Landmark Commission

LANDMARK COMMISSION REPORT

APPLICATION FOR EXTERIOR RENOVATIONS TO 403 E. ADAMS STREET

Reference Number: LC-03-18

PROPOSED SIX FOOT IRON FENCE PLACEMENT
PROPOSED BRICK UNLOADING AREA IN BOULEVARD

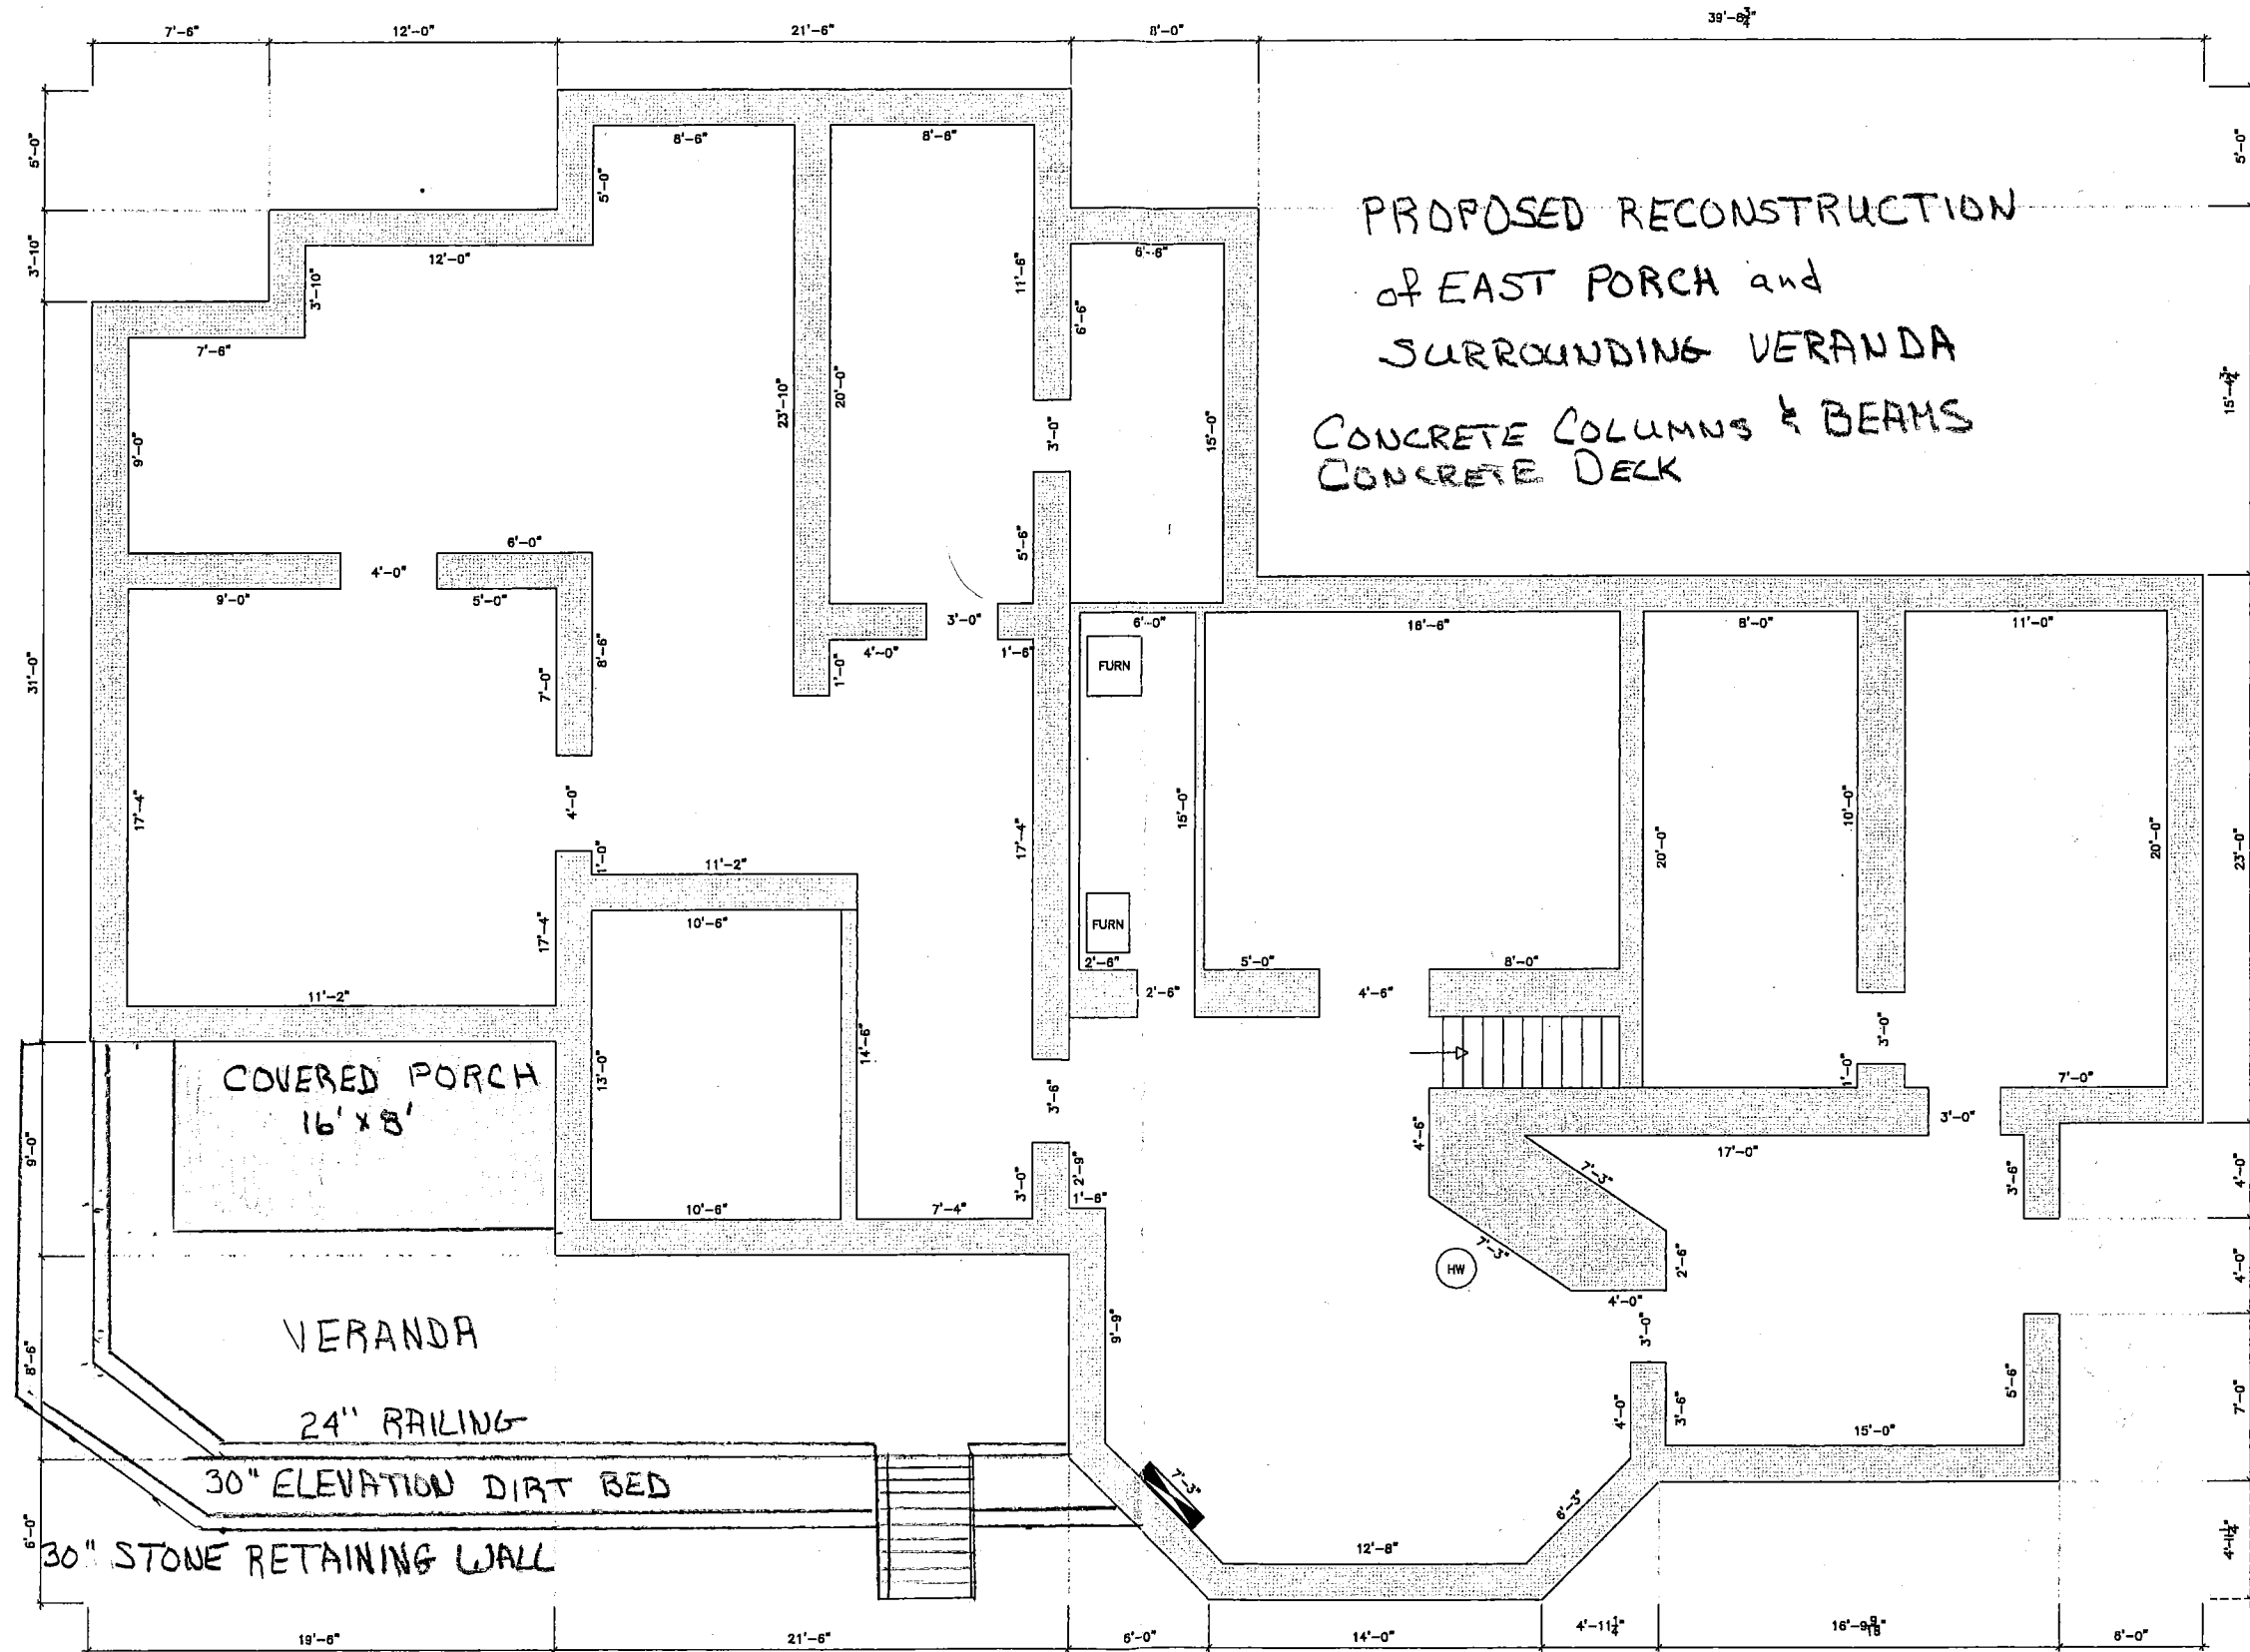
The applicant has provided a sketch of a 6' fence with openings that will contain a decorative feature. Staff has requested information from the applicant regarding what type of material the fence will be and a site plan indicating the proposed location. Staff will need to assure that the fence meets the zoning requirements in regards to height and location. The Design Guidelines state that traditional forms such as picket fence, plain board fences, and iron fencing in historic district are appropriate. Inappropriate styles would include chain link, stockade, shadow board, and other contemporary designs.

The applicant has provided a sketch of the proposed location of the fence, the proposed six foot iron fence is to surround the property. The applicant will need to apply for a variance to allow a 6' fence within the side yard.

Planning Staff believes that the applicant has provided the majority of the requested information. However, staff needs pictures of each elevation noting what is proposed for each window. The applicant has proposed a deck/ veranda with a design which is consistent with that of the time frame the home was constructed. The proposed iron fence is an appropriate material, as the design regulations stated that fence shall be of a traditional material.
